Application for Licence Amendment

Licence Number	L4680/1988/13
Licence Holder	FMR Investments Pty Ltd
ACN	009 411 349
File Number	2013/003899-1
Premises	Greenfields Processing Site Part mining tenement M15/1836 and Lot 102 on Plan 40393 Great Eastern Highway COOLGARDIE WA 6429
Date of Report	9 August 2022
Decision	Revised licence granted

This Amendment Report documents the assessment of potential risks to the environment and public health from proposed changes to the emissions and discharges during the construction and operation of infrastructure at the Premises. As a result of this assessment, Revised Licence L4680/1988/13 has been granted.

Figure 3: Standing water level from September 2017 to November 2021 at (A) all groundwater monitoring bores and (B) TSF3 Cell A monitoring bores (CMW Geosciences 2022)

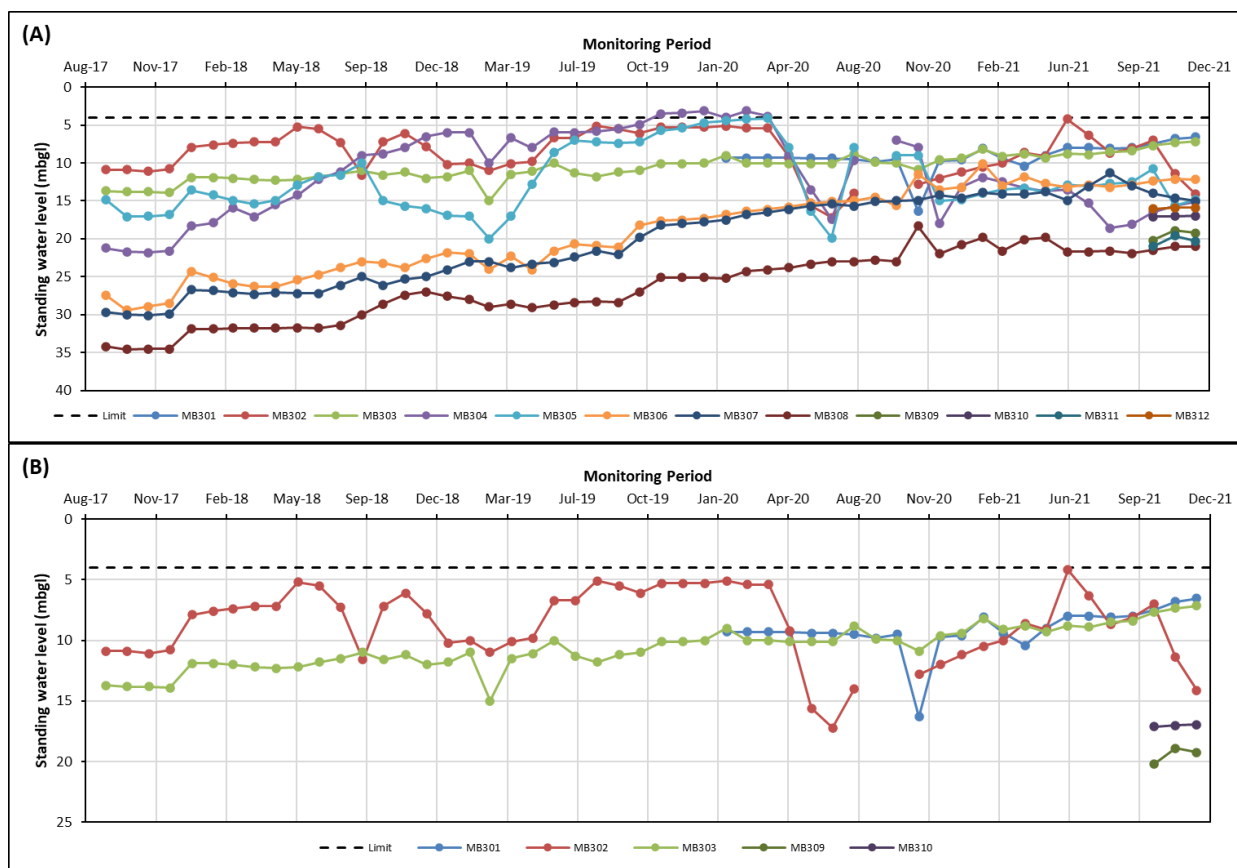
Overall, monitoring bores near TSF3 Cell A (i.e., MB301, MB302, MB303) had relatively higher SWLs, compared to the other monitoring bores (Figure 3A). Similarly, VWPs near TSF3 Cell A indicated an increase in pore pressures before stabilising. These increases coincided with the most recent embankment raise undertaken at the cell to RL402.5 m.

In 2020, MB302, MB304 and MB305 were the groundwater monitoring bores with the highest SWLs (at the time) (Figure 3). Consequently, these bores were converted to seepage recovery bores to reduce the extent of groundwater mounding, which is evident in the steep decline in SWLs in the following monitoring events. Unlike MB304 and MB305, SWL at MB302 began to rise gradually, peaking again at 4.2 mbgl (June 2021) before decreasing.

At the latest monitoring event (December 2021), monitoring bores MB301 and MB303 have SWLs shallower than seepage recovery bore MB302, at 6.56 mbgl and 7.14 mbgl, respectively. While the licensed limit has not been breached yet, these trends suggest that seepage recovery at MB302 may not be adequate long-term.

Only preliminary SWL data is available at monitoring bores MB309 and MB310 due to the recent installation (Figure 3A). Nevertheless, it is evident that the water table at those bores (i.e., 300 m south of TSF3) were not yet impacted by seepage mounding to an extent that presents a risk to vegetation at the surface. Continued monitoring is required to establish the rate of mounding, if present.

The Delegated Officer has reviewed the Licence Holder’s proposed controls related to construction and operation of the TSF3 Cell A and considers that potential seepage may increase with the additional pressure due to the construction of this TSF embankment lift. However, seepage management actions and monitoring controls will continue to be implemented to allow corrective actions to be taken as necessary. The Delegated Officer considers the consequence rating for the risk event ‘seepage impacts’ to be **moderate** due to potential for stress / death of vegetation. A review of the groundwater monitoring SWL data indicates that increasing seepage trends may lead to groundwater mounding into the root zone of nearby vegetation, thus likelihood of vegetation impacts is **possible**. The final risk rating for this risk event is therefore ‘**medium**’.
